**STATE OF HAWAII  
DEPARTMENT OF TRANSPORTATION  
AIRPORTS**

**ADDENDUM NO. 3  
FOR  
SOUTH RAMP VIDEO MONITORING ACCESS CONTROL (VMAC) SYSTEM  
AT DANIEL K. INOUE INTERNATIONAL AIRPORT  
HONOLULU, OAHU, HAWAII  
STATE PROJECT NO. AO1095-37**

**March 4, 2026**

**GATE SCHEDULE AND TEMPORARY CONCRETE BARRIER FENCE DETAIL**

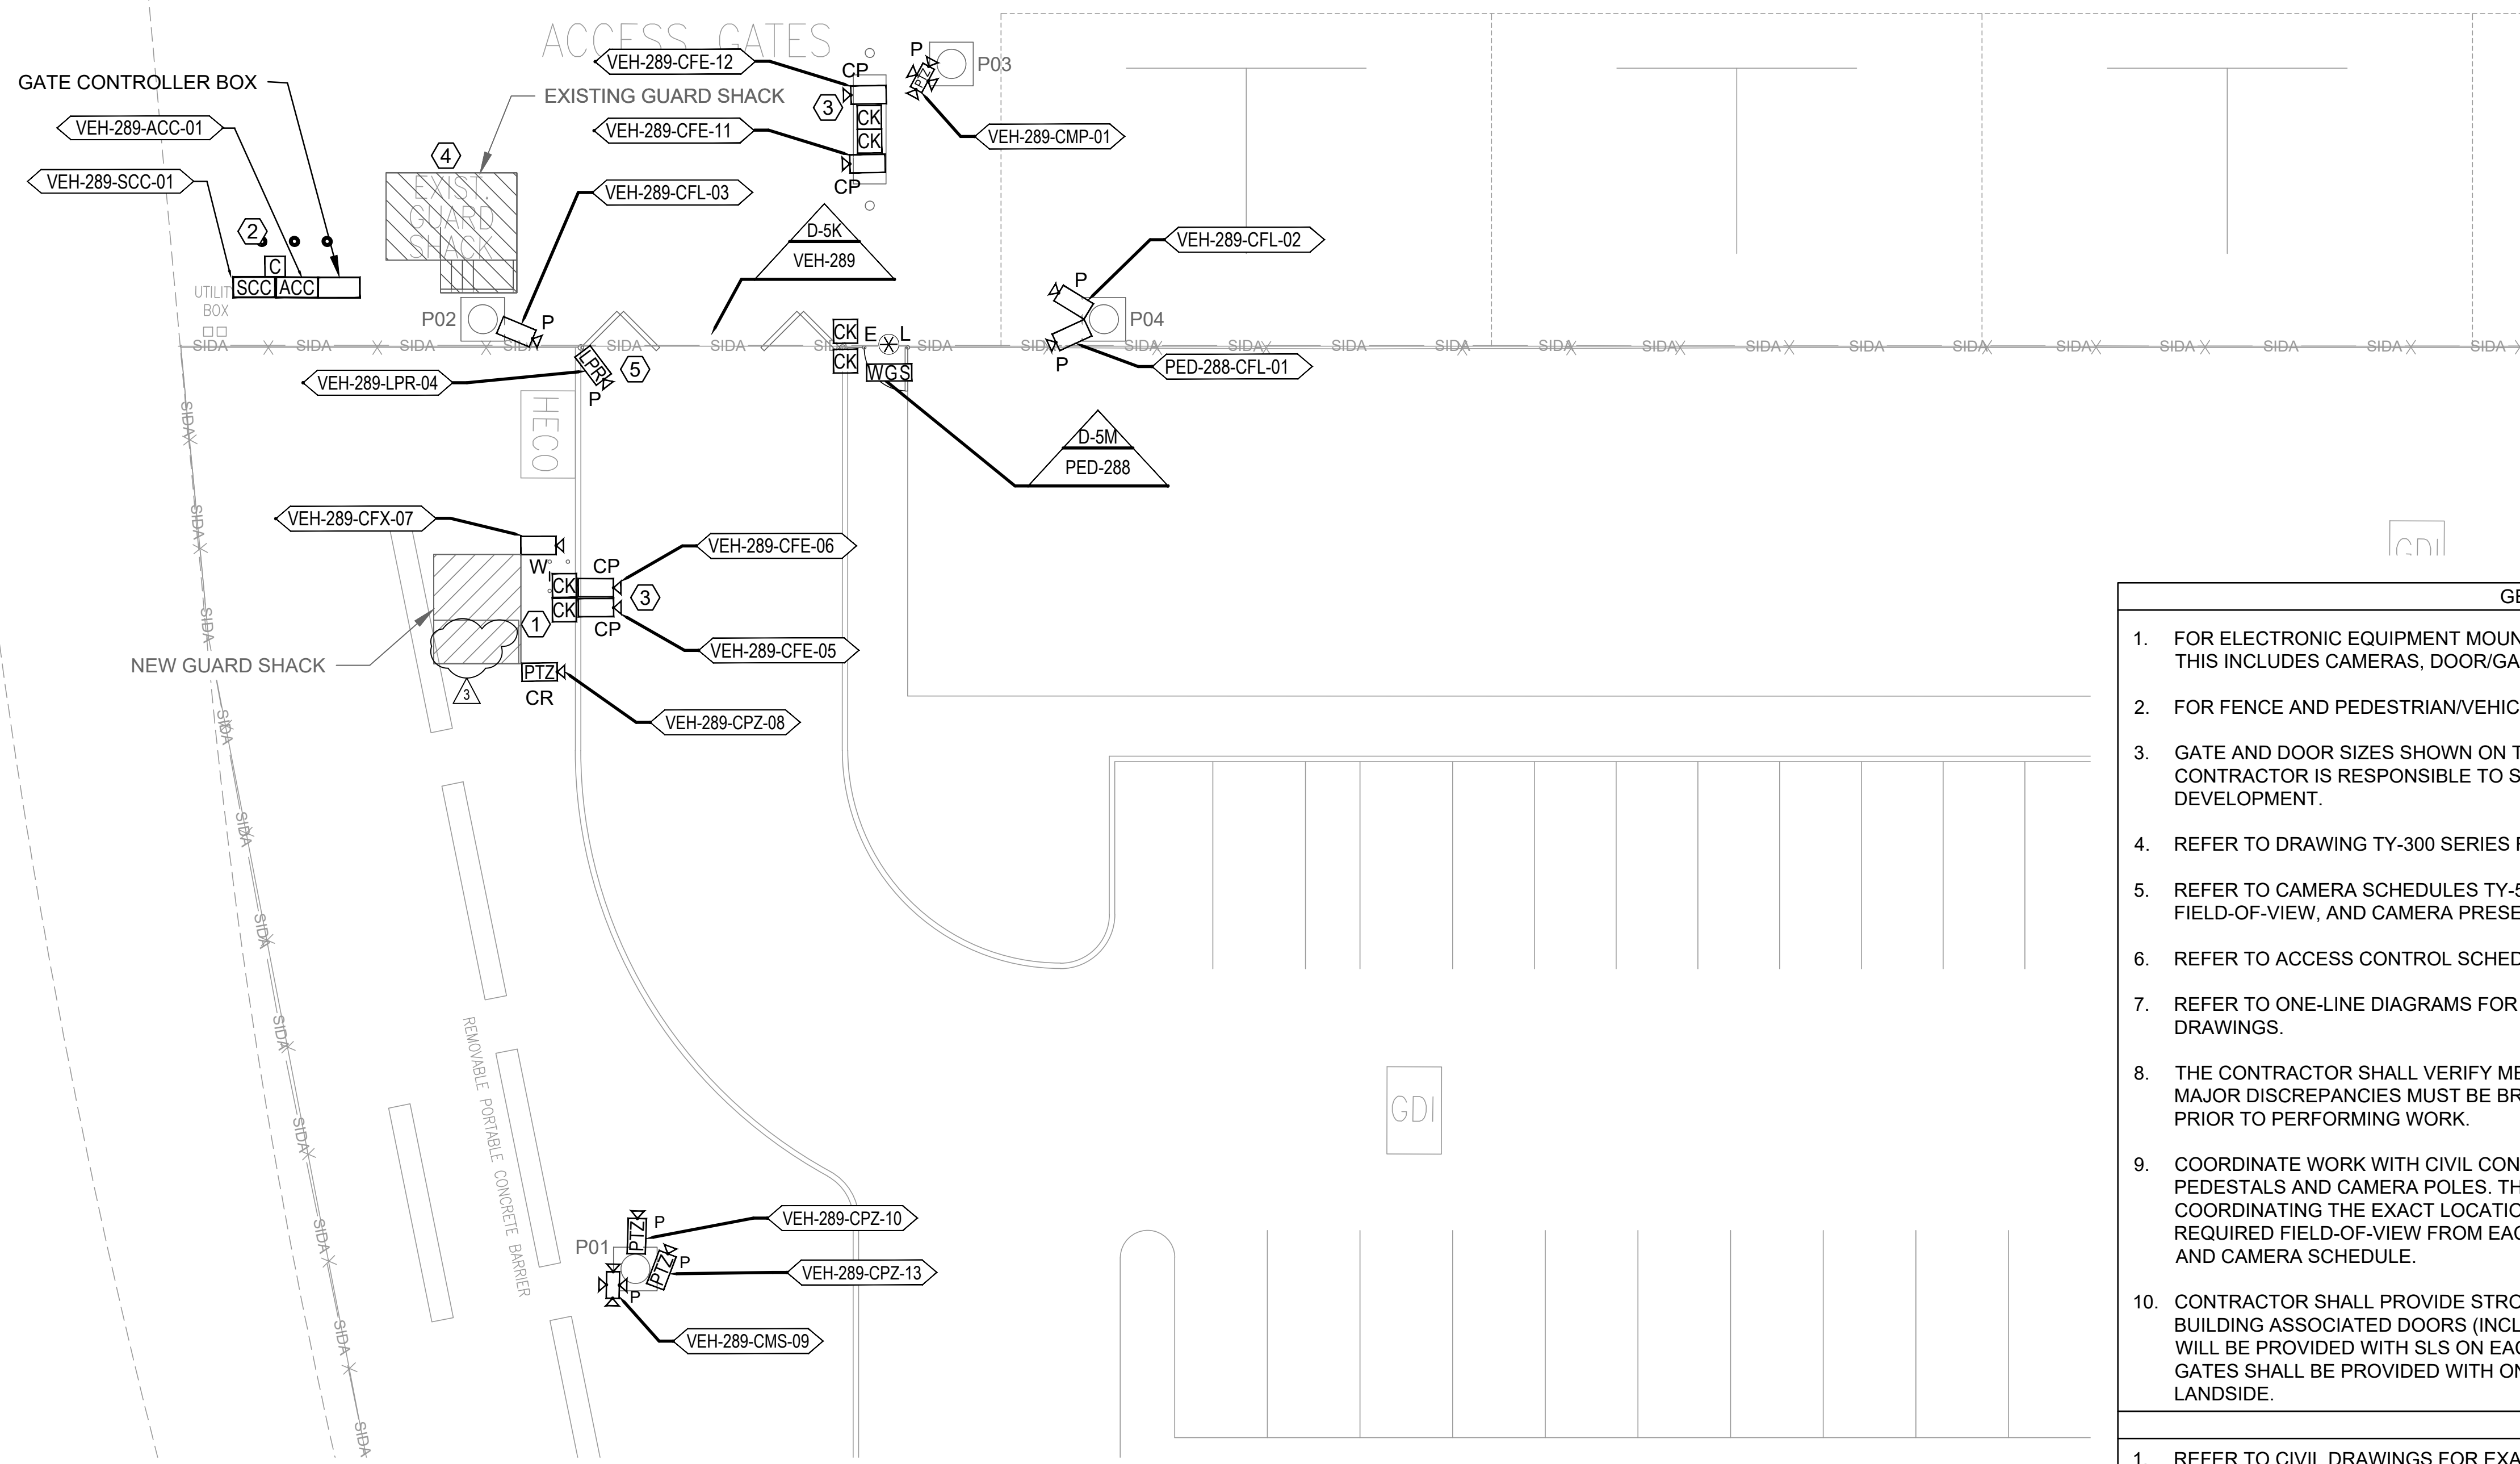
3. Delete **PLANS DRAWING NO. C-150 GATE SCHEDULE** and replace it with attached **PLANS DRAWING NO. ADD. 3 C-150 GATE SCHEDULE AND TEMPORARY CONCRETE BARRIER FENCE DETAIL**.

Response: Temporary fencing shall be TSA-compliant and be a minimum of 6-ft high with 3-strands of barbed wire and subject to the acceptance of the Engineer. Temporary fencing may consist of 6-ft high chain link fence with 3-strands of barbed wire on movable concrete barriers (Jersey Barriers, K-Rail Barriers, or similar). See revised Sheet C-150.

- DETAIL NOTES:**
- CONTRACTOR SHALL MAINTAIN SECURE PERIMETER BY PROVIDING TEMPORARY CONCRETE BARRIER FENCE SEGMENTS FOR ALL REMOVED SECTIONS OF EXISTING FENCE. TEMPORARY CONCRETE BARRIER FENCE SHALL REMAIN IN PLACE DURING BOTH CONSTRUCTION AND NON-CONSTRUCTION WORK HOURS FOR ONGOING FENCE CONSTRUCTION LOCATIONS.
  - TEMPORARY CONCRETE BARRIER SEGMENTS SHALL HAVE INTERLOCKING CAPABILITY. GAP BETWEEN INTERLOCKING CONCRETE BARRIER AND FENCE SEGMENTS SHALL BE A MAXIMUM OF 2-INCHES.
  - ALL GATE FRAME JOINTS SHALL BE WELDED.
  - POST AND BRACES SHALL BE SCHEDULE 40 (STANDARD WEIGHT) PIPE. SIZES SPECIFIED ARE OUTSIDE DIAMETER.
  - ALL FENCING MATERIAL SHALL BE GALVANIZED STEEL.
  - TEMPORARY CONCRETE BARRIER FENCE SHALL BECOME PROPERTY OF DOT-A UPON COMPLETION OF THIS PROJECT.

**SHEET TITLE:**  
**VMACS PLAN VEHICLE GATE VEH-289 & PEDESTRIAN GATE PED-288**

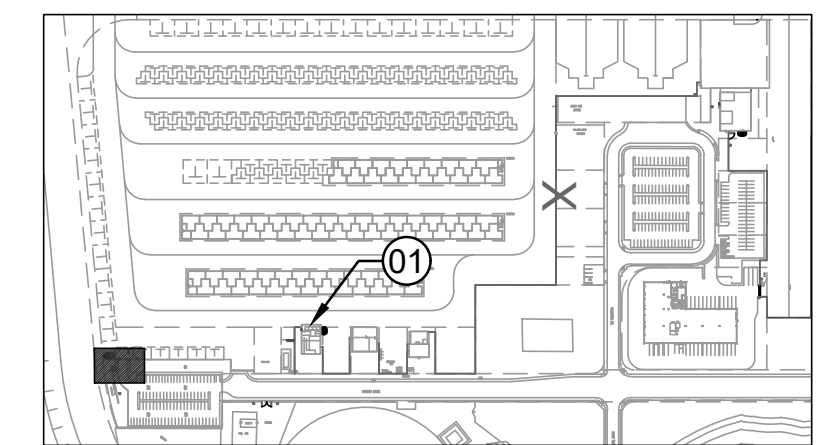
4. Delete **PLANS DRAWING NO. TY-106 VMACS PLAN VEHICLE GATE VEH-289 & PEDESTRIAN GATE PED-288** and replace it with attached **PLANS DRAWING NO. ADD. 3 TY-106 VMACS PLAN VEHICLE GATE VEH-289 & PEDESTRIAN GATE PED-288**.

Response: Delete this monitor. See revised Sheet TY-106.

Response: Delete this monitor. See revised Sheet TY-106.

**SHEET TITLE:**  
**VMACS PLAN TRANSAIR BUILDING 34**

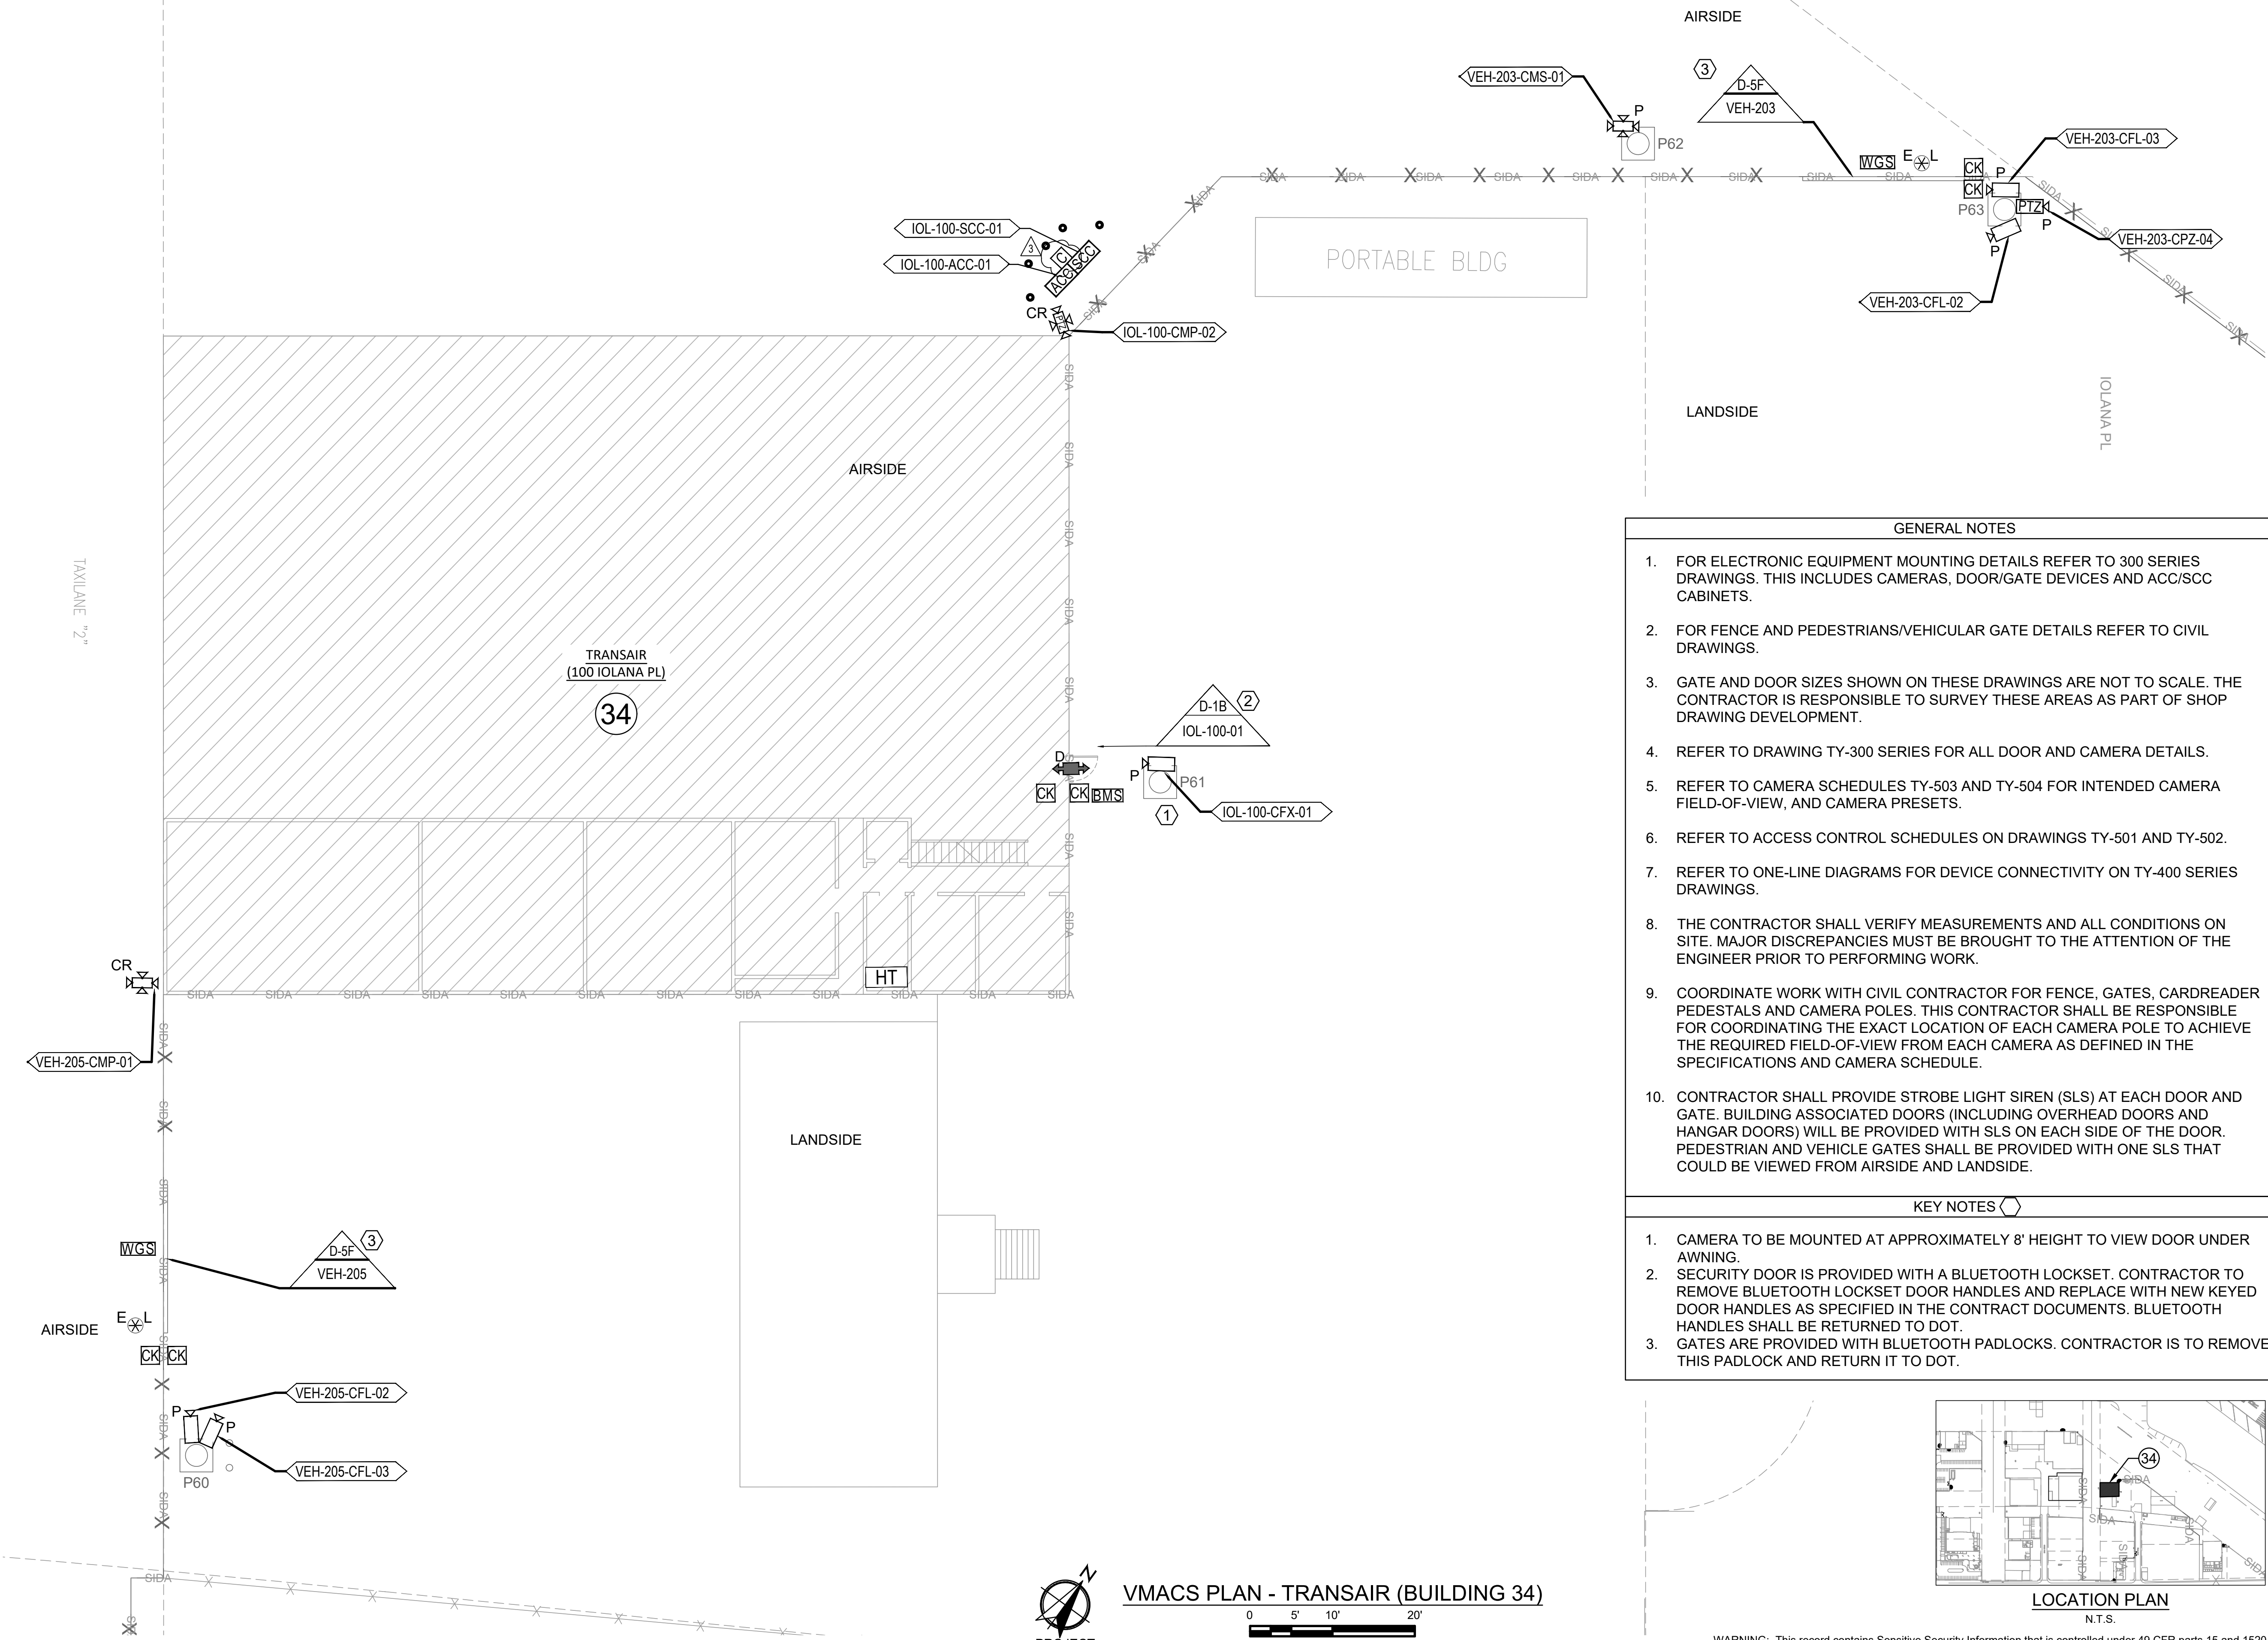
5. Delete **PLANS DRAWING NO. TY-132 VMACS PLAN TRANSAIR BUILDING 34** and replace it with attached **PLANS DRAWING NO. ADD. 3 TY-132 VMACS PLAN TRANSAIR BUILDING 34**.

**45. SCC/ACC location on drawing TY-132 does not show a card reader. Please confirm if not needed.**
